APPEAL SUMMARY

Appeal ID: 21908	Project Address: 2316 SE 28th PI
Hearing Date: 9/25/19	Appellant Name: Corey Cliffe
Case No.: B-006	Appellant Phone: 503-231-5631
Appeal Type: Building	Plans Examiner/Inspector: Ken Majors
Project Type: residential	Stories: 2 Occupancy: R-3 Construction Type: V-B
Building/Business Name:	Fire Sprinklers: No
Appeal Involves: Alteration of an existing structure	LUR or Permit Application No.: 19-215603-RS
Plan Submitted Option: pdf [File 1] [File 2]	Proposed use: SFR with ADU

Cliffe Renovation
 2316 SE 28th Place, Portland, OR 97214
 drawn by: jcw
 date: 08/20/16
 revision: none

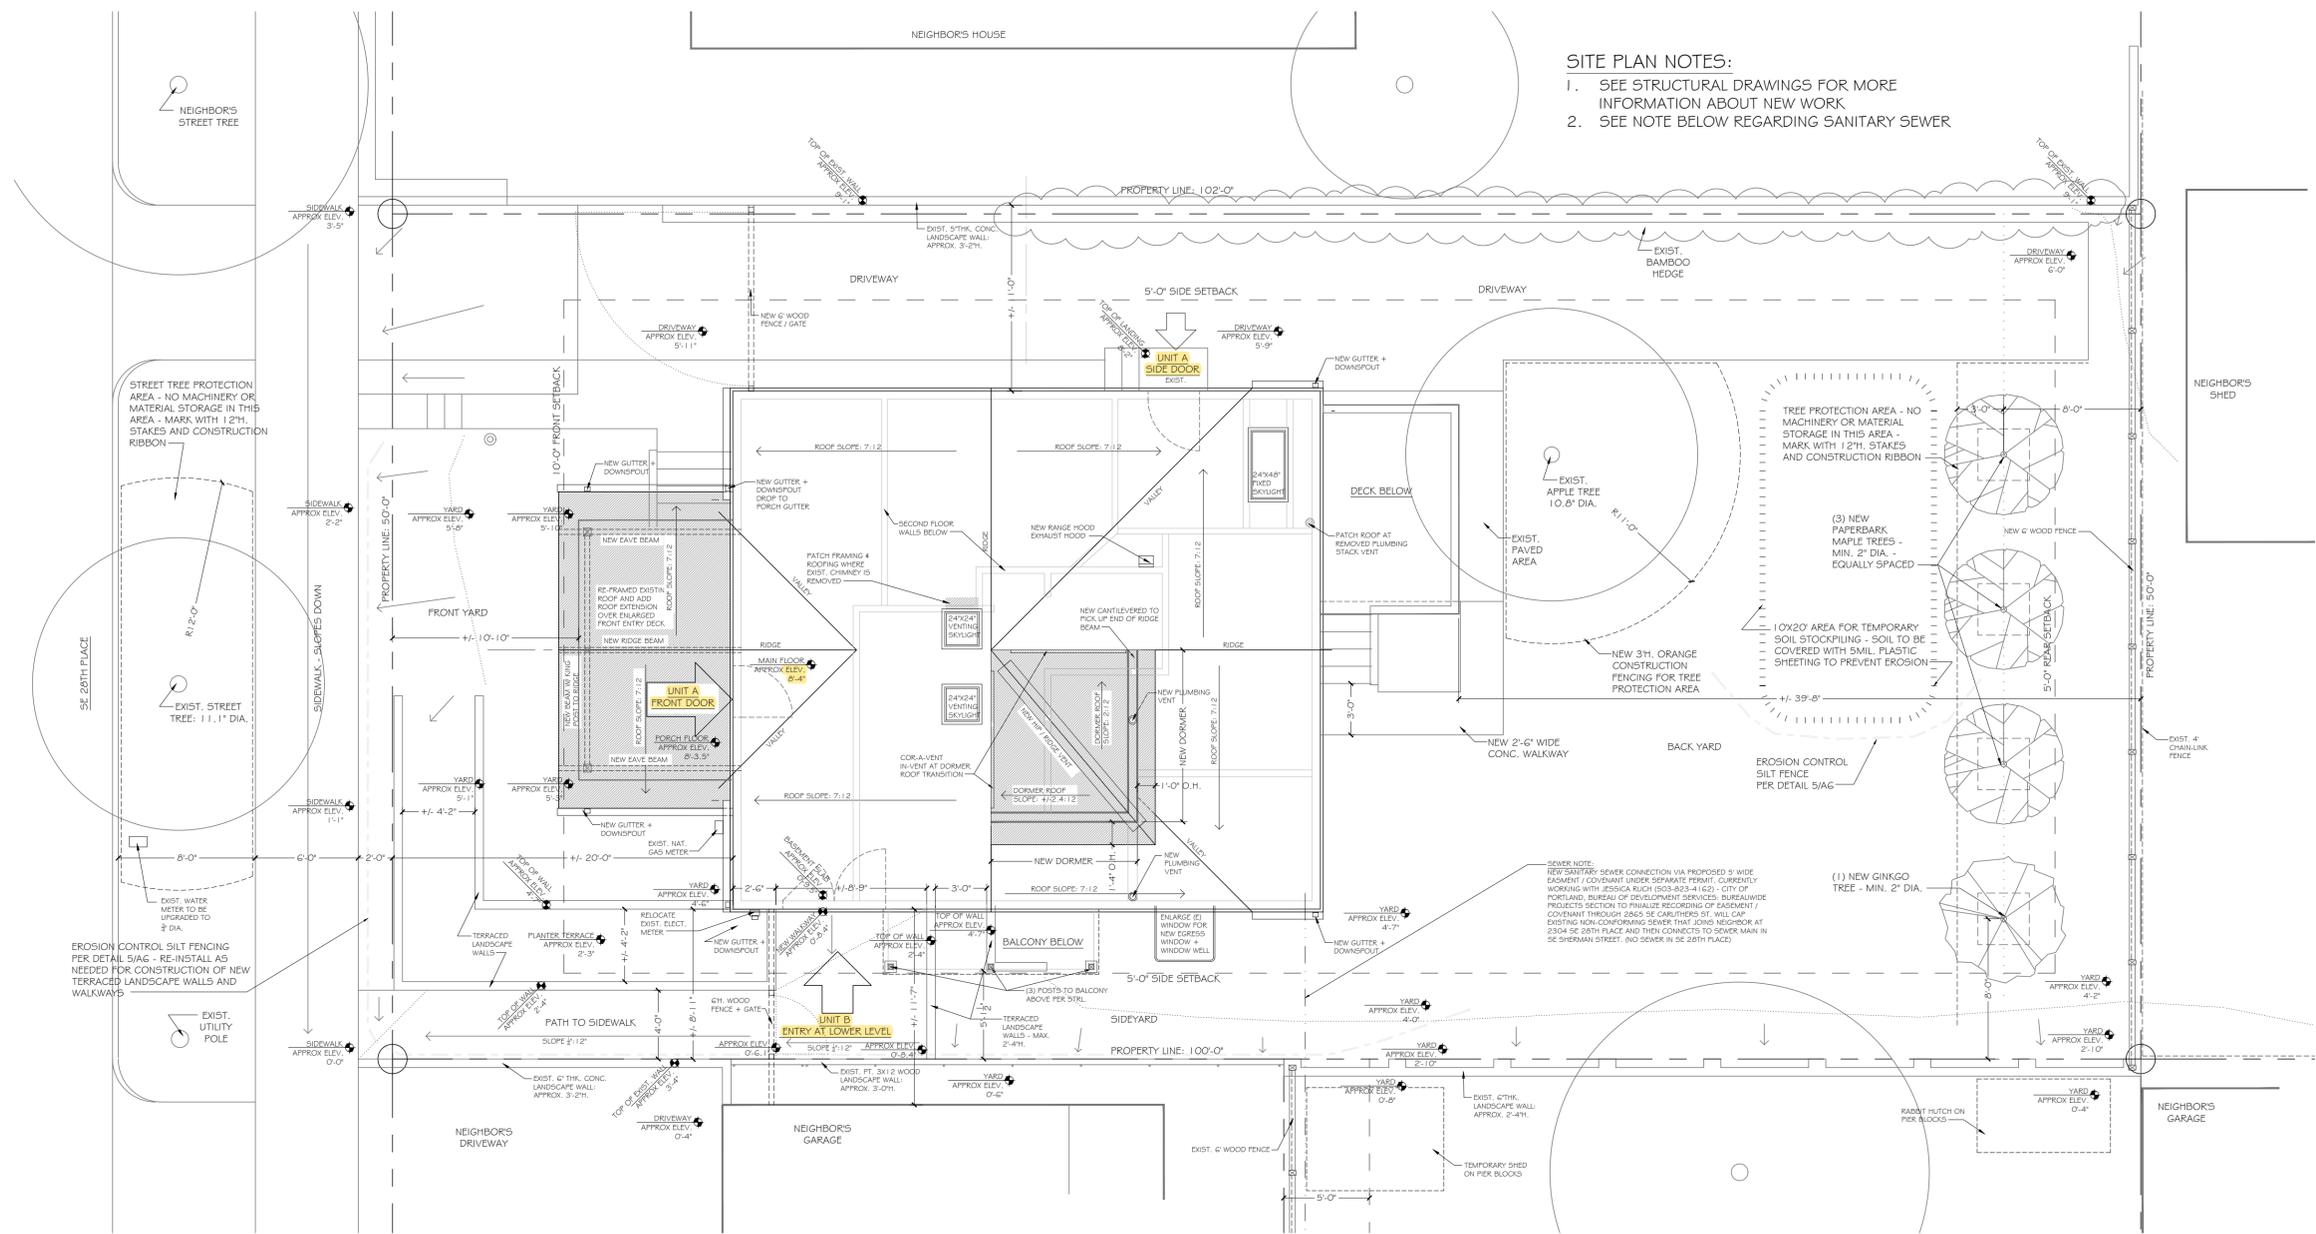
Proposed Design There will be a door in the newly constructed wall on the main floor between the Unit A - Hall and the New Stair to 2nd Floor providing access from the new Entry at Lower Level to the new 2nd floor, Unit B - ADU. The door will be a 60-minute rated door with smoke gaskets and a closer.

Reason for alternative The ADU / Unit B is being created for the owner's adult son to live in close proximity to the owner's elderly parents who will occupy the main floor / Unit A. The parents are needing more support and care-giving, and the doorway will provide access between the units to facilitate this.

The door will be a 60-minute, fire rated door, with smoke gaskets and a closer which completes the wall assembly required for a 1-hour rating between the 2 units.

Communicating door between ADU and main dwelling unit: **Granted as proposed.**
